# Tank Closure and Waste Management Environmental Impact Statement

**January 2010**

# Focus on Effects of Offsite Waste at Hanford

## **Ecology's View**

Figure 1: Iodine-129:TC Alternatives 2B and 3A in combination with FFTF Alternative 2 and WM Alternative 2.

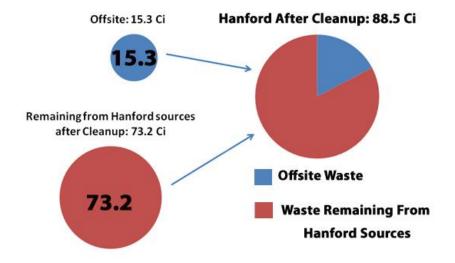
**Iodine-129**: The numbers for the different alternatives are identical with 17 percent coming from offsite sources (Figure 1).

Figure 2: Technetium-99: TC Alternative 2B in combination with FFTF Alternative 2 and WM Alternative 2.

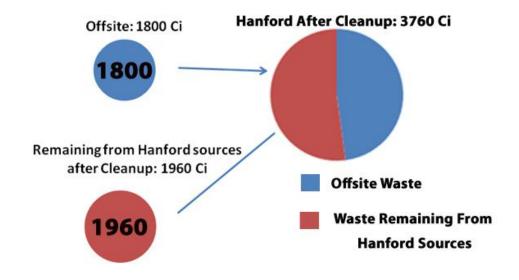
**Technetium-99:** In TC-3A, the remaining inventory onsite will be about ten times larger than for TC-2B because 3A removes technetium. In TC-2B (Figure 2), the offsite waste will almost double the inventory remaining on the Hanford Site. Offsite waste will contribute only 6% of the inventory for Alternative TC-3A (Figure 3).

Figure 4: **lodine-129: TC Alternatives 2B (left) and 3A (right) in combination with FFTF Alternative 2 and WM Alternative 2 (in curies.**)

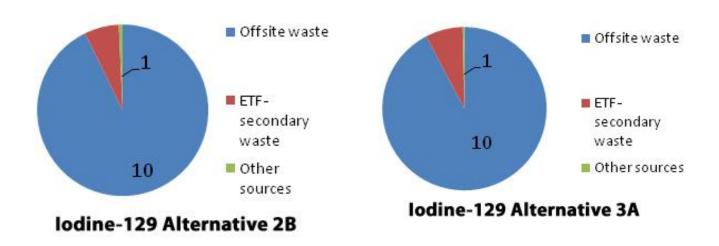
**Iodine-129**: The offsite waste contributes 90% of the iodine released to the groundwater (Figure 4) when the offsite waste is combined with waste from both Tank Closure Alternative 2B and Alternative 3A.

Figure 5: Technetium-99: TC alternative 3A (left) and 2B (right) in combination with FFTF alternative 2 and WM alternative 2 (in curies).

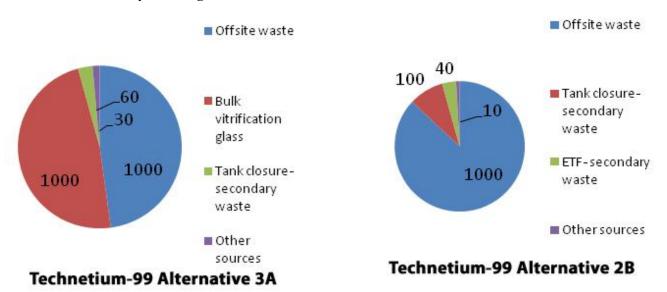
**Technetium-99:** The offsite waste contributes 87% of the technetium-99 released to the groundwater (Figure 5) when the waste is combined with waste from Tank Closure Alternative 2B. In TC Alternative 3A, the offsite waste contributes 48% of the released technetium. Hanford's waste release smaller amounts of technetium, and more slowly, because it is in vitrified low activity waste glass.

Figure 6. Offsite waste impacts.

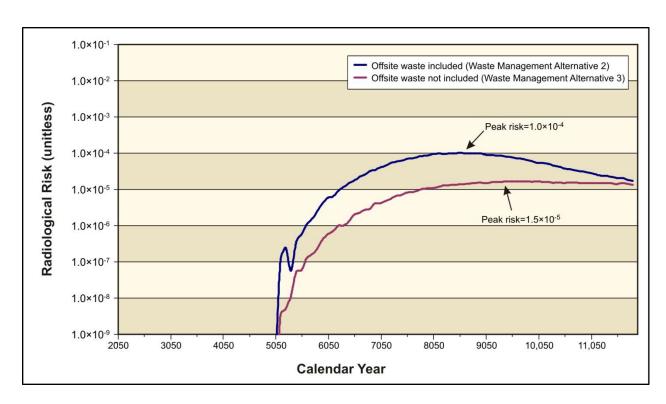
Figure S-21 from the draft EIS summary shows the impact of offsite waste disposal at Hanford.
